# REGIONAL REVIEW NOTIFICATION

**ARC REVIEW CODE:** R2107231

**Name of Proposal:** Mixed-Use Development at Peachtree-Wieuca DRI #3383

GSWCC NO. (LEVEL II) 0000068765  
DRAWN BY: ATB  
DESIGNED BY: IDK  
REVIEWED BY: BWS  
DATE: 07/12/2021  
PROJECT NO: 012826043  
TITLE: **DRI SITE PLAN**  
SHEET NUMBER: **DRI-1**

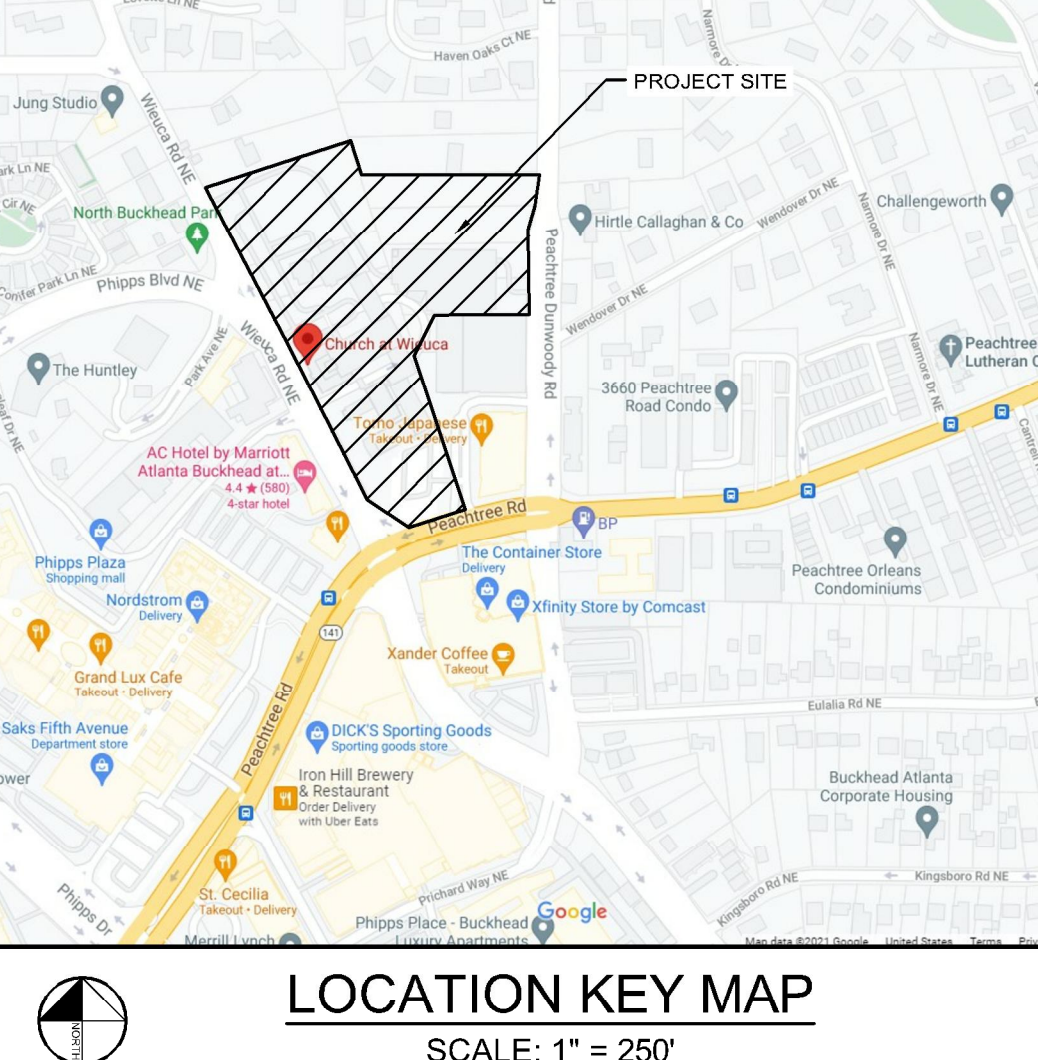
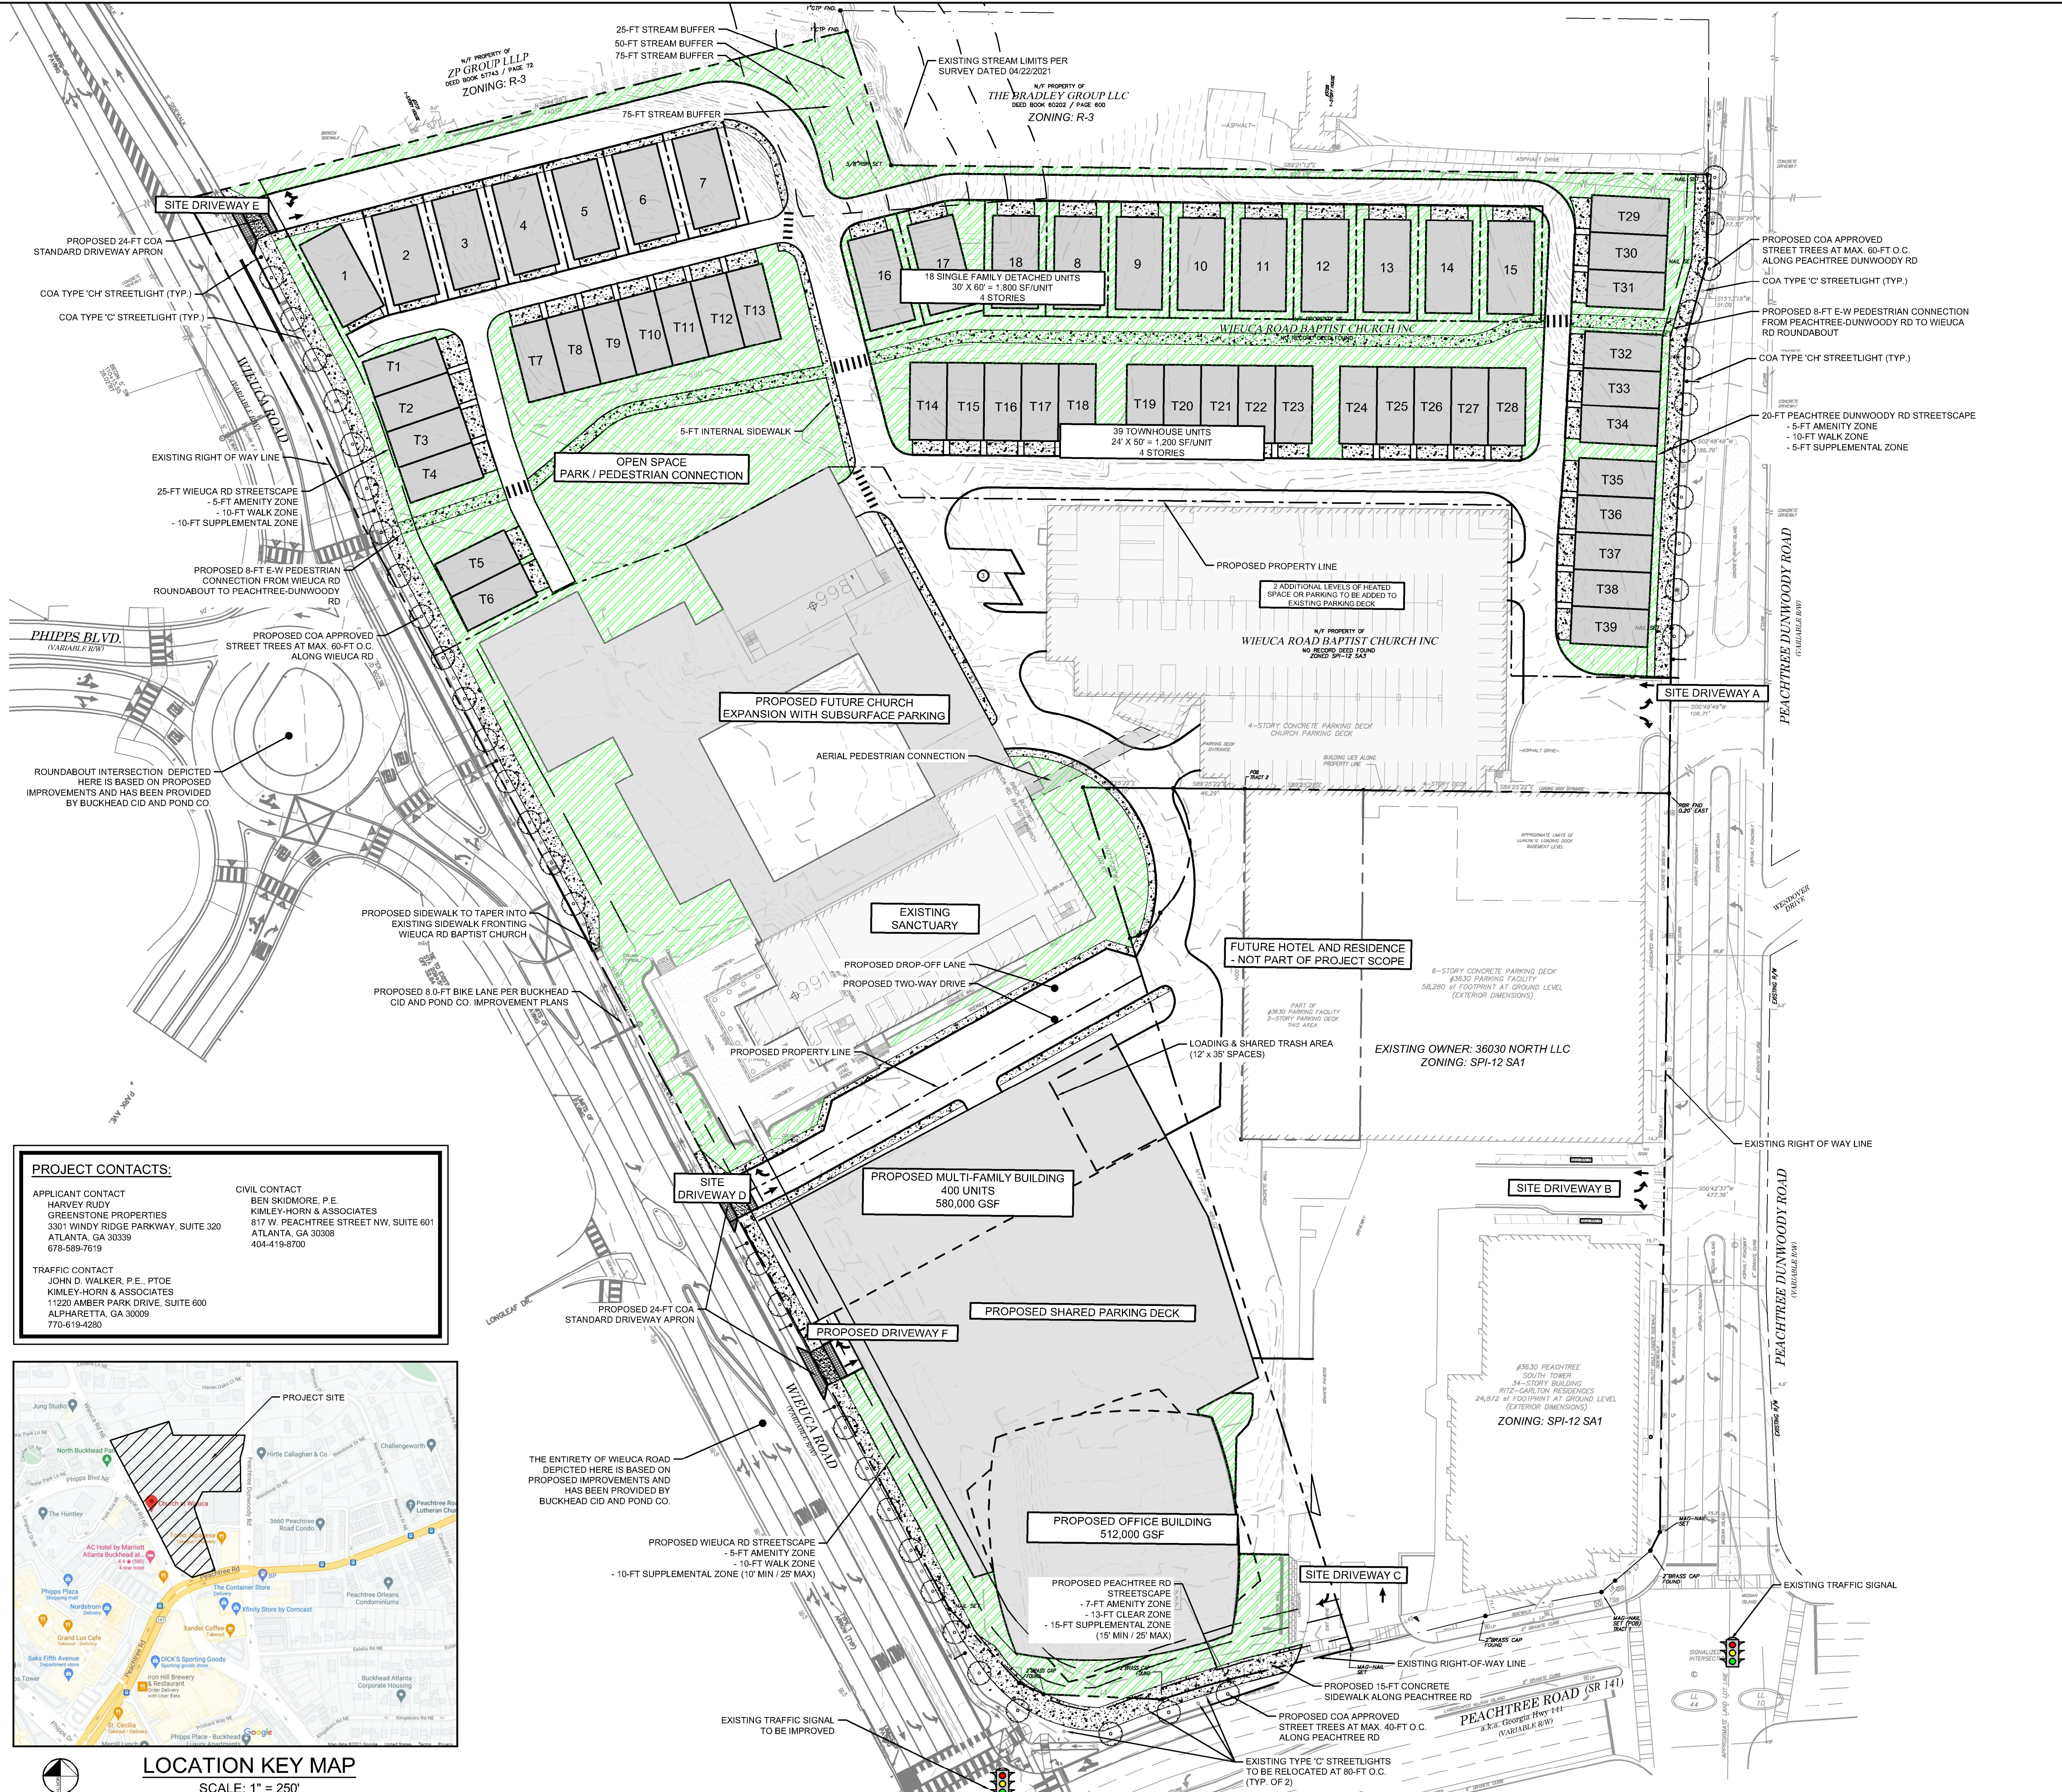
The USGS coverage for the project area does not show any streams on or near the property. However, the submitted site plan shows a stream starting in the north central portion of the property. The City 50-foot undisturbed buffer and 75-foot impervious setback are shown, as is the State 25-foot Erosion and Sedimentation Act buffer. The stream and the buffers are crossed by a proposed driveway. This and any other intrusions into the buffers may require variances. Any unmapped streams on the property may be subject to the City's Stream Buffer Ordinance. Any waters of the state that may be on the property will be subject to the State 25-foot Erosion and Sedimentation Buffer requirements.
